Product Change Notification

PCN-075_2022_1-OMTM2203401

Marking change (UKCA) + Data sheets modifications + insulation test voltage change AP and APR series – **First date code**

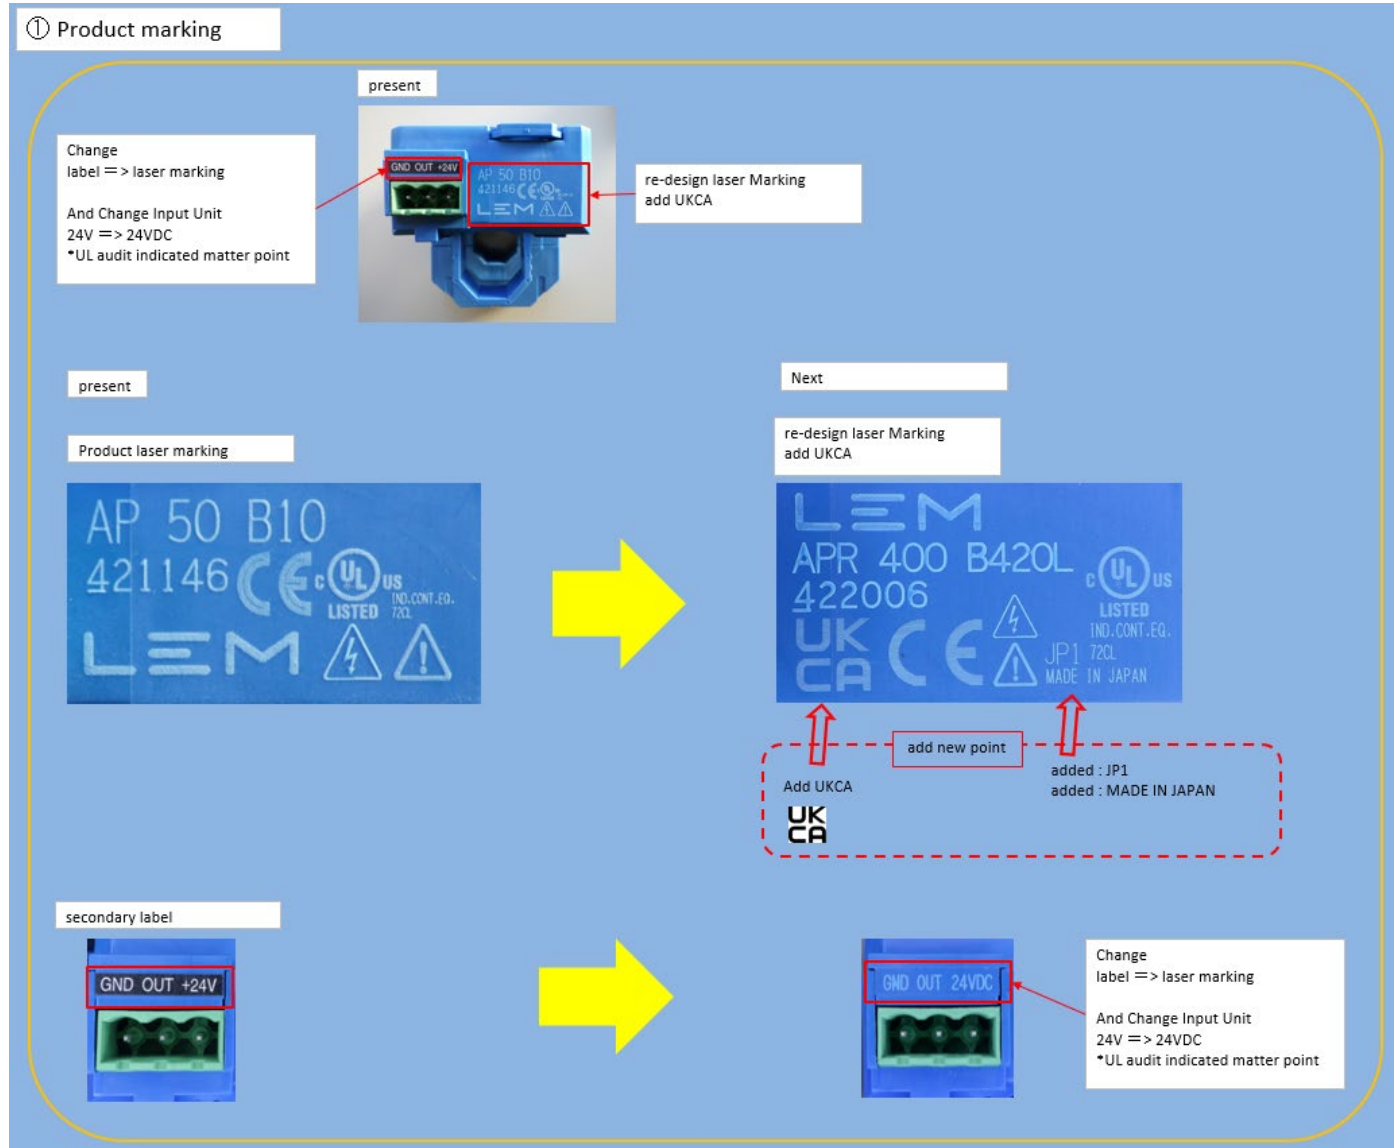
Change 1: Marking change: Add UKCA marking. Layout of the full marking change due to UKCA marking adding.

Change 2: Marking for the connections identifications of the secondary connector changes from label to laser marking and Input voltage marking change from "+24V" to "24VDC".
